AIRCRAFT DESIGN PROPOSED BY SQN.LDR.G.L.WALLER
FEASIBILITY STUDY

COMMENTS ON AIRCRAFT DESIGN PROPOSED BY Sqn. Ldr. WALLER, R.A.A.F.

AIRCRAFT WITH ANNULAR AEROFOIL

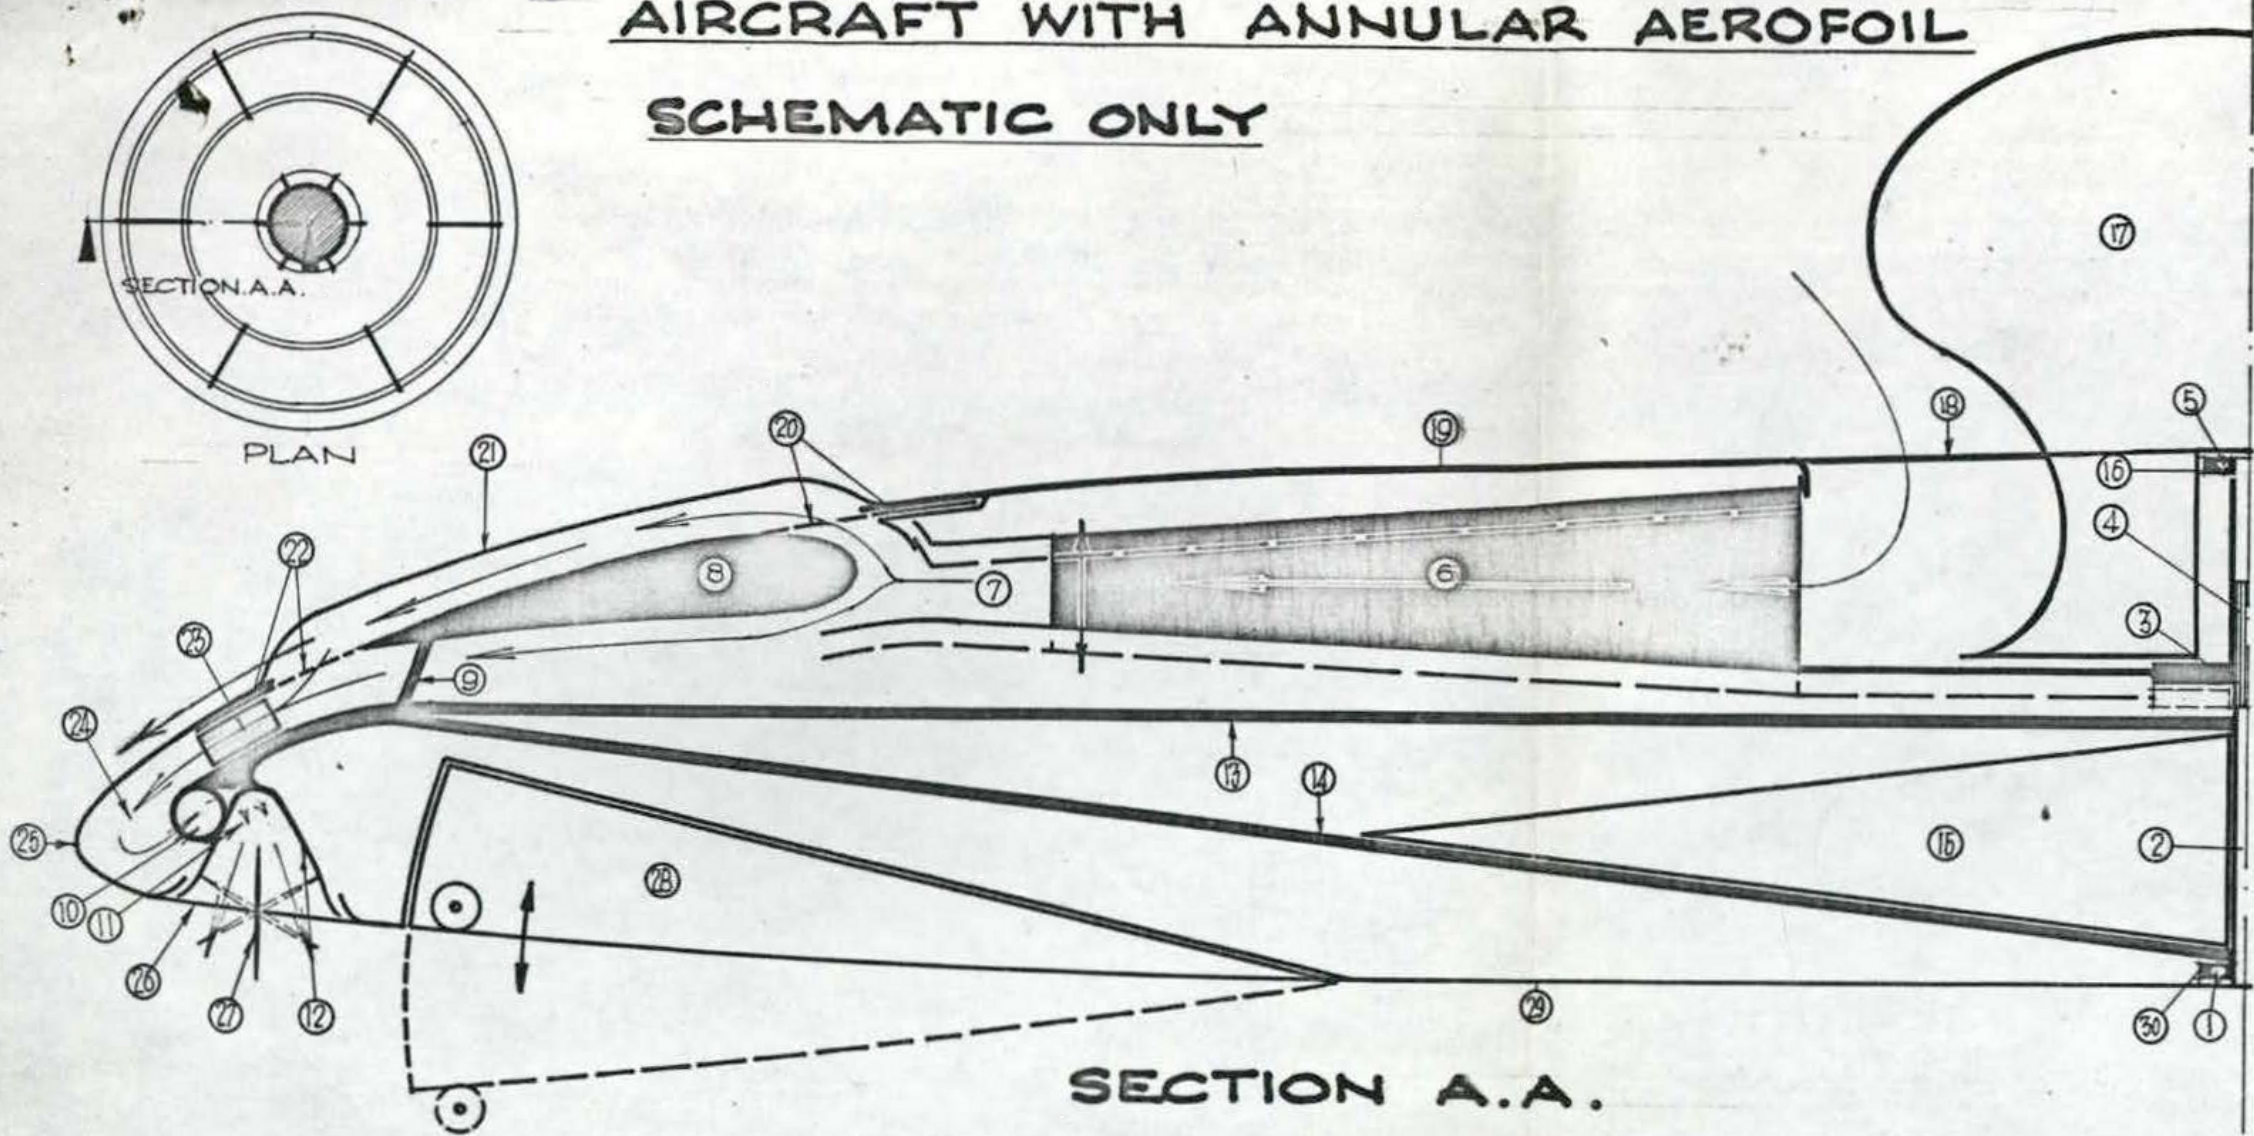
The data provided by Squadron Leader Waller is too inadequate to attempt a precise feasibility study, but attention is drawn to certain basic principles which are involved.

A momentum balance taken around the entire system shows that the ring aerofoil cannot produce more lift than the upward component of the reaction produced in turning the horizontal jet vertically downward. Thus the maximum lift obtainable, under ideal conditions with no losses, is completely determined by the momentum entering the system in the initially-horizontal jet. The ring wing acts merely as a turning vane, so that designing it for an excessively-high lift will result in over-turning of the jet and an actual decrease in the vertical reaction.

It should further be observed that the above maximum lift will only be developed if the jet comes cleanly away from the aircraft. If any part of the jet is reabsorbed into the aircraft system so as to reduce the total vertical downward component of the momentum finally ejected, the resultant lift on the system will be reduced accordingly.

If the lower value (2000 lb.) is taken, together with the given fan mass flow of 3.09 slug/sec. (1300 c.f.s.), then the radial velocity required in the incident jet is approximately 650 f.p.s.

Neglecting compressibility effects, the jet height at exit from the 6 ft. diameter fan will thus be 1.25 inches. It can be seen that submerging a wing of, say, 1.5 to 2 ft. chord in a jet of this thickness could pose difficulties.

$$\frac{1.09 \times 650^2}{2 \times 550} = 1185$$

Alternatively, if we take the incident-jet radial velocity at, say, 100 f.p.s., the mass flow required will be 20 slug/sec. (i.e. approximately 7 times the given value), and the ideal H.P. required will be 182.

It is assumed that it is proposed to run a centrifugal fan without a volute to produce a flow all around the periphery, and although we can find no data for use in this condition, a preliminary calculation implies that, for 100 f.p.s. radial exit velocity and volume flow of 1300 c.f.s., the efficiency is likely to be less than 50%.

At this stage it is only possible to say, in view of the foregoing remarks, that there does not seem to be any obvious aerodynamic advantage in the proposal over systems obtaining lift by direct axial acceleration of a vertical jet.
